TOWN OF PARADISE VALLEY

Sanctuary Resort & Spa Statement of Direction

Town Council Meeting April 12, 2018

GALLERY HOUSE & GUEST HOUSE

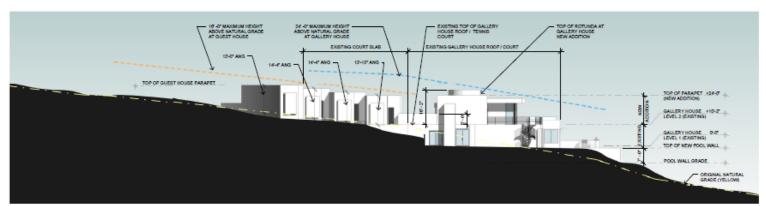
- PC shall focus review on visible effects amendment may have on neighbors. Review shall focus on:
 - Lighting, screening of mechanical equipment, setbacks, heights, parking/circulation, and material pallet of improvements
 - Potential noise and visibility impacts that Gallery House outdoor deck/living area may have on neighboring properties
 - Location and setbacks of guest house building. Since guest house does not meet recommended 60' front yard setback, PC shall review proposed setbacks of guest house building
